SSSES-FSAR

QUESTION 032.1

Section 1.6 references GE topical report NEDO-10466, "Power Generation Control Complex Design Criteria and Safety Evaluation." This topical report is presently undergoing review. Therefore we require that this topical report be included as a reference in the appropriate section of Chapter 7 and that you provide a commitment to adopt the resolution on this topical report achieved between GE and the staff. In addition, address in the FSAR all the interface requirements of the topical report.

FIGURE 032.6-1, Rev 47

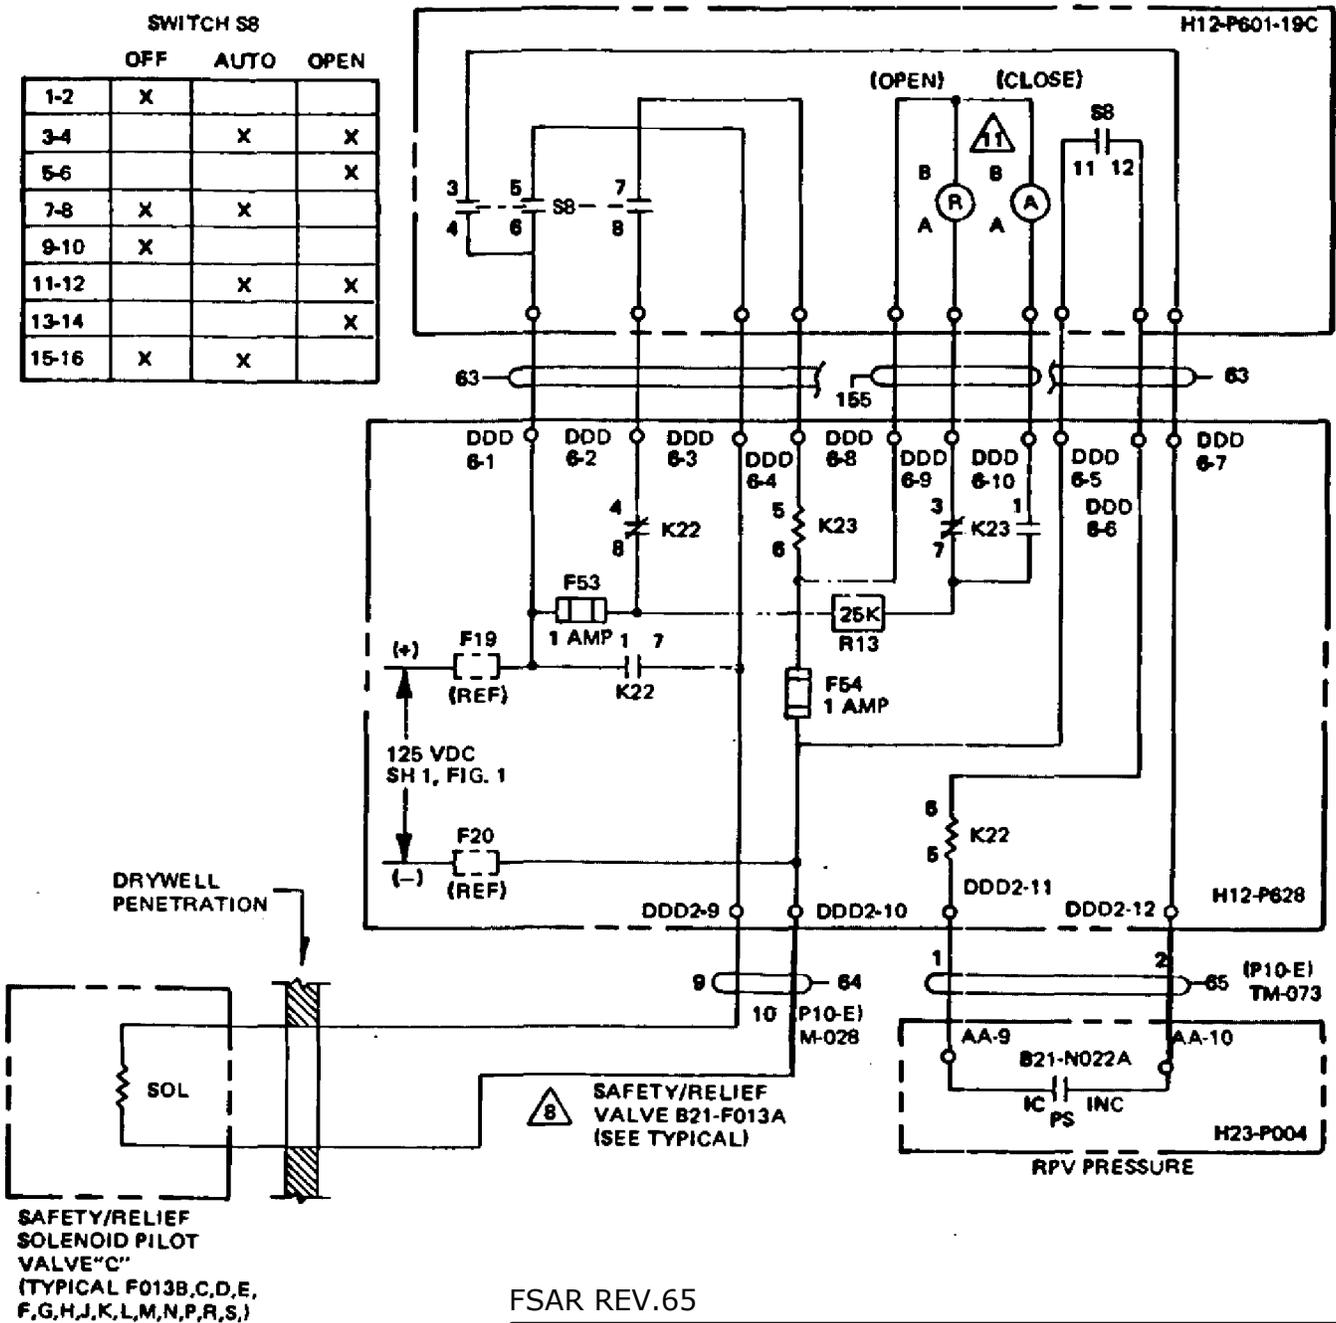
Provide a complete discussion of the instrumentation (pressure switches, manual control switches, and wiring) associated with the nuclear pressure relief system described in Section 5.2.2.4 of the FSAR which actuate the safety/relief valves on an overpressure event or through operator action. Include elementary wiring diagrams as appropriate.

The pressure relief instrumentation which controls the electrical operation of each valve is shown on Figure 032.6-1 (typical diagram). Each valve has its own pressure switch which acts to open the valve directly when it senses high vessel pressure unless the control switch (S8 in the diagram) is in the "OFF" position.

This control switch is a maintained contact switch which may be selected for one of three positions: OFF, AUTO or OPEN. With the switch in "AUTO", pressure at or above the setpoint closes the pressure switch which actuates a relay which opens its respective valve while simultaneously switching indicating lights. When pressure drops to an acceptable level, the pressure switch reopens causing the relay to deenergize and reclose the valve.

Manual control for opening the valve is initiated by simply placing the switch in "OPEN" thereby bypassing the pressure switch relay and opening the valve directly from the switch contact (5-6 in diagram).

FIGURE 032.18-1, Rev 47

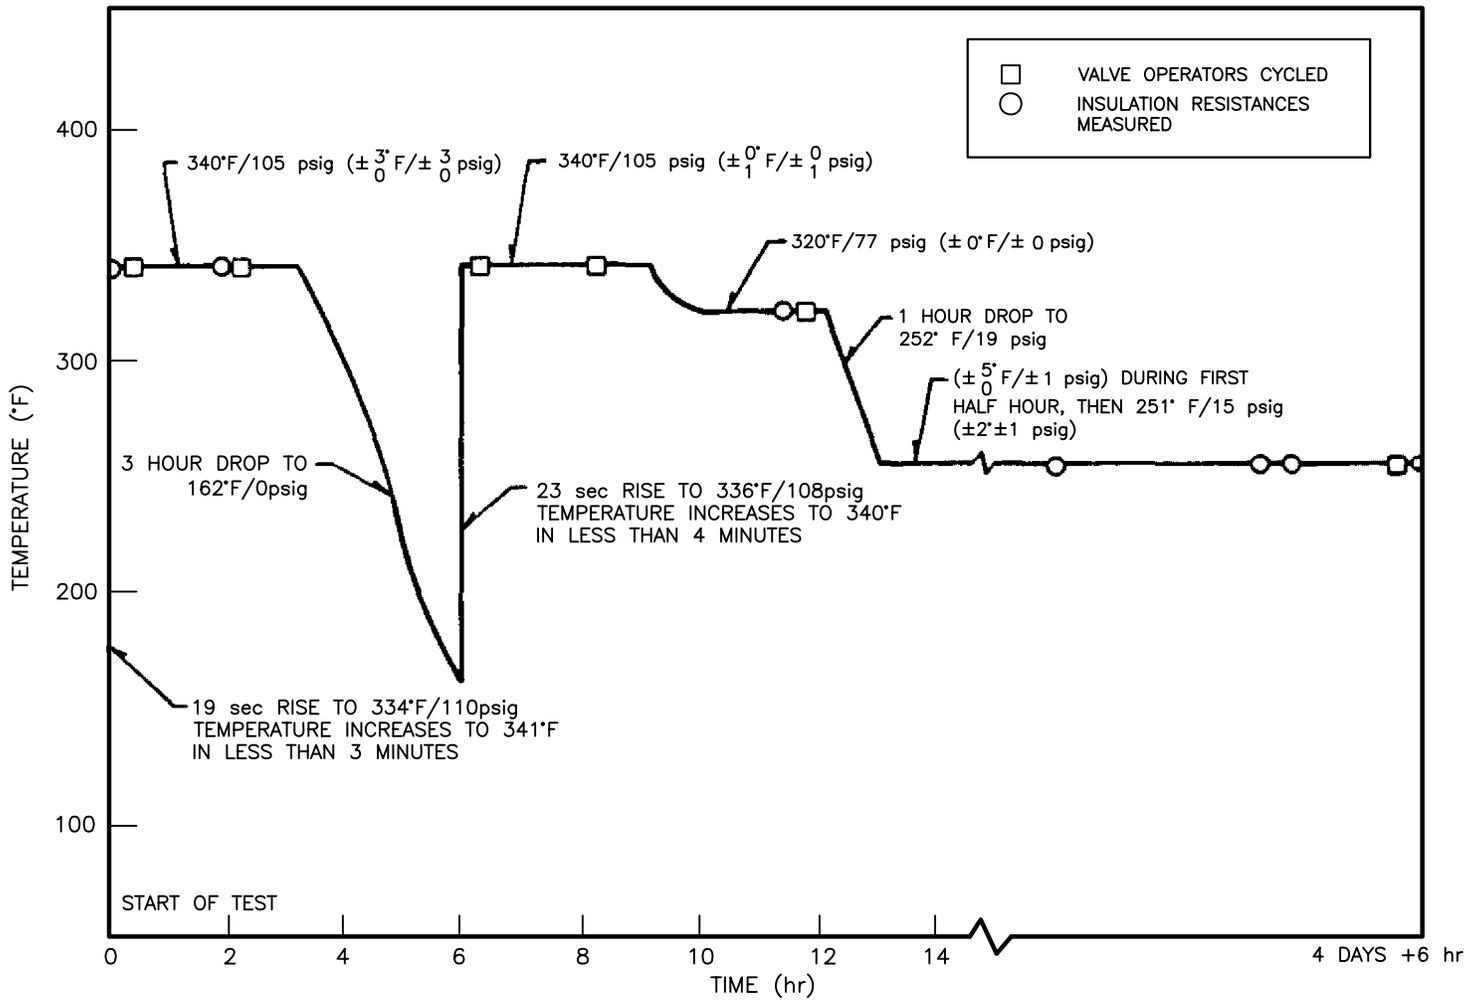
- (2) Provide a copy of the procedures for the following aging simulations:
 - (a) Thermal,
 - (b) Radiation,
 - (c) Operation, and
 - (d) Seismic.
- (3) Justify the aging temperature which was used in terms of the maximum normal environmental conditions which are listed in FSAR Table 3.11-1.**

3. Thermal conditions - see Figure 0.32.18-1;
 4. Mechanical aging - 500 cycles, open and close; and
 5. Radiation exposure - see response to part 6.
 - c. The mounting configuration for the valve and operator was specified as mounted in a nominally horizontal run of pipe with the valve stem nominally vertical.

FIGURE 032.57-1, Rev 47

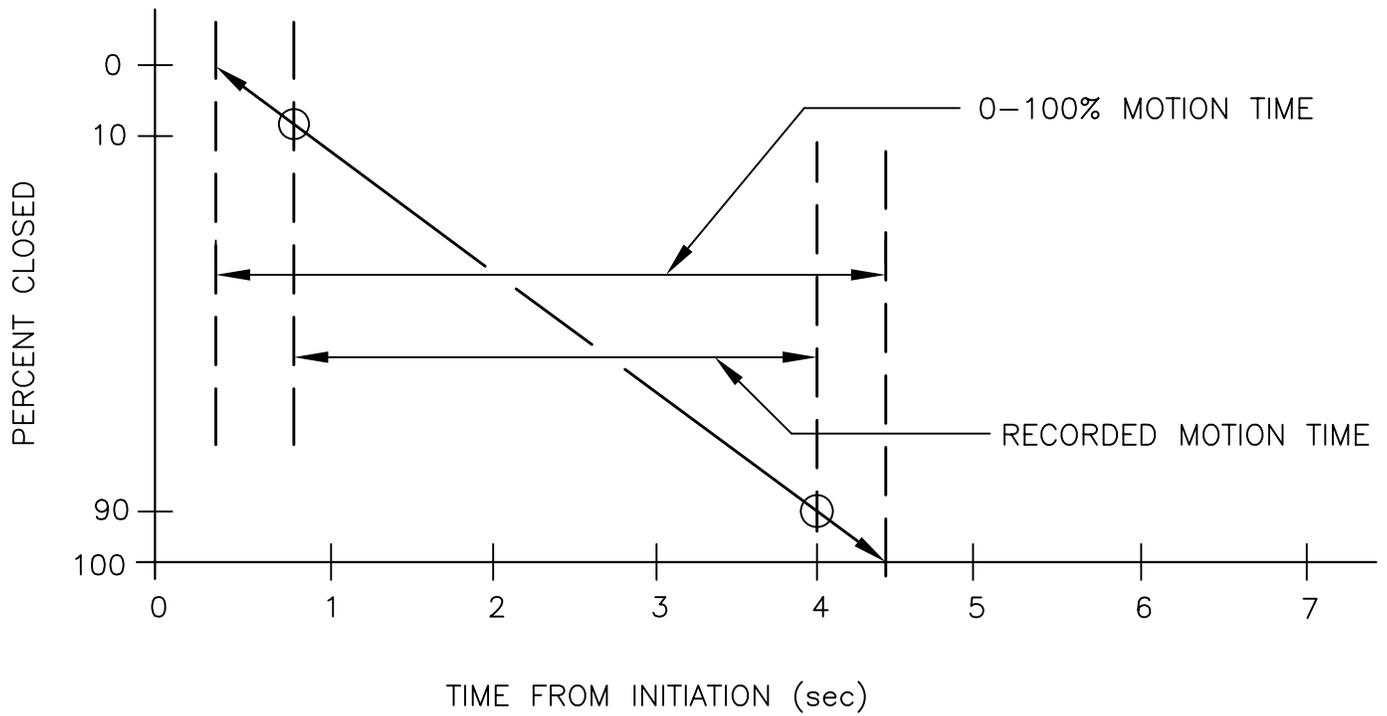
Describe test method to be used to verify closing times for main steamline isolation valves are within limits of technical specifications. Identify any special design features to facilitate this test. Table 6.2-12 is referenced for closure times of main steamline isolation valves, but time has been omitted from that table. What is the range of acceptable closure times?

The determination of the MSIV closure was an extrapolation from the position lights as illustrated by Figure 032.27. The closure time is the summation of the time between the initiation signal and the 90% closed light plus 1/9 times the time interval between the initiation and the 90% closed lights.
